REPORT TO DESIGN REVIEW BOARD

SUBJECT: 33/41 Ross Street Terrace – Request for a Lot Line Adjustment for property line adjustment, Exception, and Environmental and Design Review Permits to allow for the following: (1) Construction of a single-family residence on vacant hillside Lot 59; (2) Construction of a single-family residence on vacant hillside Lot 60; and (3) Construction of a two lane access driveway approximately 480 feet in length within the undeveloped Ross Street Terrace right-of-way; APN: 012-141-59 and 012-141-60; Single-family Residential (R7.5) District; Coby Freidman, applicant. File No(s): LLA19-008 / ED19-090 / ED19-091 / EX20-006.

Figure 1: Proposed Site Plan

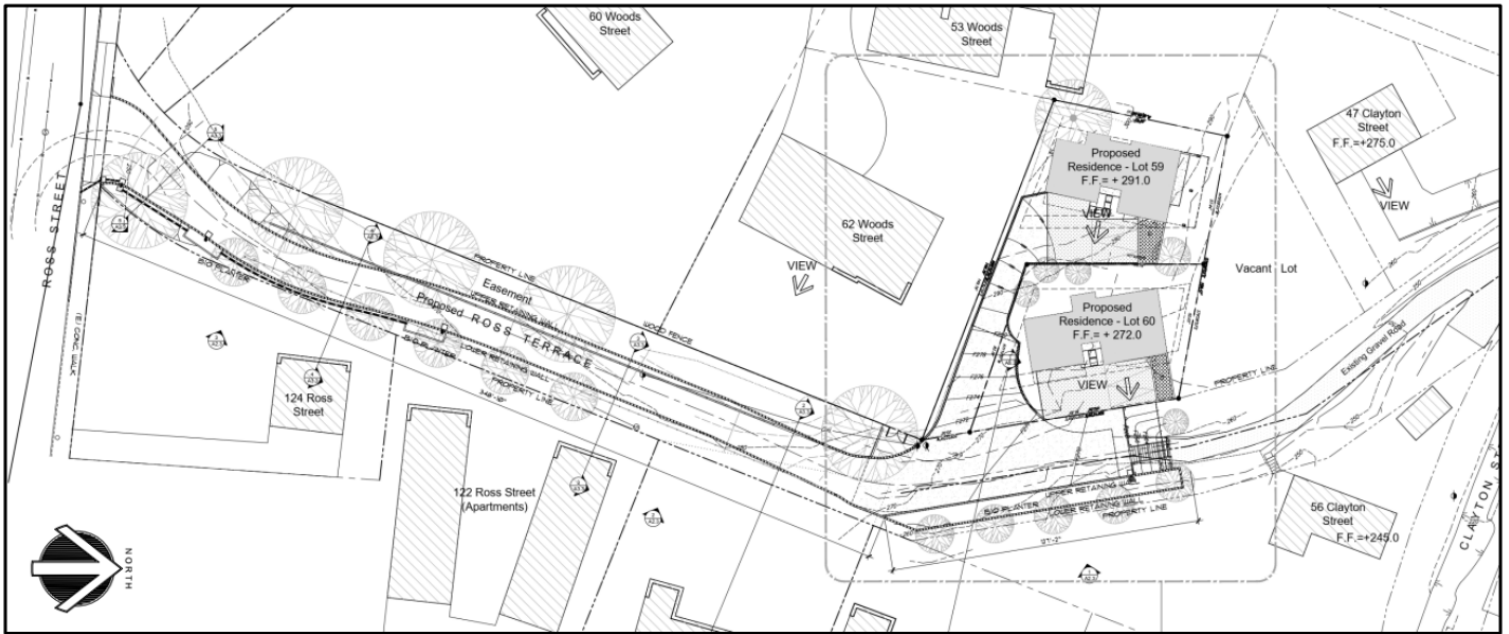
- Felt there needed to be a second guest parking space for each unit. (See project changes discussion.)
- Wanted the applicant to see if the height of retaining walls could be reduced and/or softened visually. (See project changes discussion.)

- Asked if the amount of impervious surface be reduced. (See project changes discussion.)
- Felt that additional landscaping was needed around the double retaining walls below the lower residence. (See the project changes discussion.)

- Wanted a less visually massive railing system for the access drive. (See project changes discussion.)
- Felt that the development of the adjacent vacant lot should be considered as part of this project. (See project changes discussion.)

Plan Change: Increased the amount of pervious surface by adding pervious pavement in front of each unit (outside of the right-of-way for Ross Terrace).

Plan Change: Added a second onsite guest parking space for each unit.

Plan Change: Reduced the height of the retaining wall on the access drive.

Effect/Result: The portion of access drive near Ross Street has been moved toward the southern side of the Ross Street Terrace right-of-way. Re-aligning the access drive reduced the height of the tallest retaining wall from a maximum height of 12 feet to a maximum height of 9.5 feet.

Plan Change: Added additional landscaping between the double retaining walls.

Effect/Result: Additional shrubs and groundcover were added in the retention basin between the two retaining walls in front of the lower unit.

Plan Change: Provided a less visually prominent driveway rail design.

Effect/Result: The project plans propose a less visually prominent a steel cable guardrail system. The applicant is also proposing a more attractive Versaloc block system for the retaining walls.
